UNITED STATES DEPARTMENT OF THE INTERIOR **BUREAU OF LAND MANAGEMENT** SUNDRY NOTICES AND REPORTS ON WELLS AUG 23 2012

PLUG AND ABANDONMENT PROCEDURE

San Juan 30-4 Unit #64H

Re: Permanent Abandonment Well: 64H San Juan 30-4 Unit

Plugged

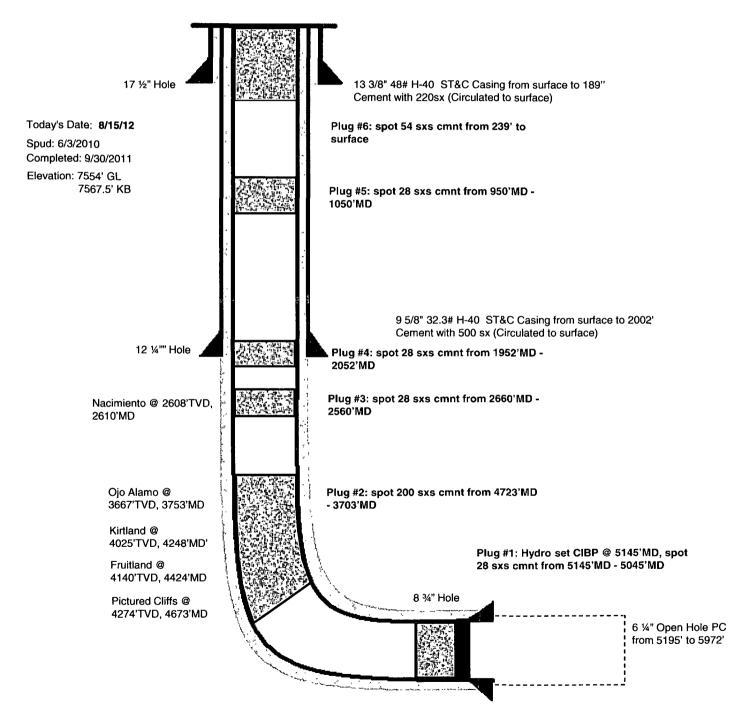
- 1. Plugging operations authorized are subject to the attached "General Requirements for Permanent Abandonment of Wells on Federal and Indian Lease."
- 2. Farmington Office is to be notified at least 24 hours before the plugging operations commence (505) 564-7750.
- 3. The following modifications to your plugging program are to be made:
- a) Place the Nacimiento plug from 2586' 2486'.

2586 2486
